Access Compliance Report

Public Rights-of-Way

| Intersection ID: 47499 | Main Street: STACCATO_ST | Cross Street: BEVERLY_CREST_BV | Location: NE |
| ADA ID: FD78DAF39F1B | Ramp Type: Perp | Initial Pass/Fail: Fail | Overall Compliance: No |

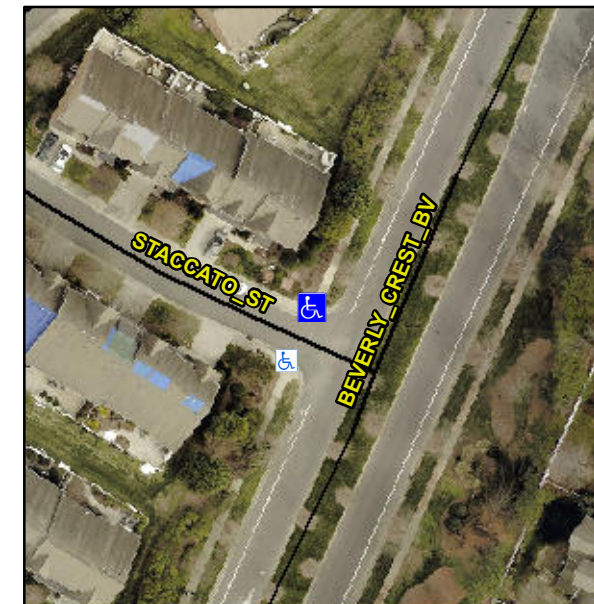
Not Found, R304.5.1, R304.5.3

| Compliance | Description | Data | Compliance | Description | Data |
|------------|-----------------------|-------|------------|-----------------------------|------|
| No | Ramp Width (in) | 35.0 | No | Ramp XSlope (%) | 3.6 |

Remove & Replace Entire Ramp.
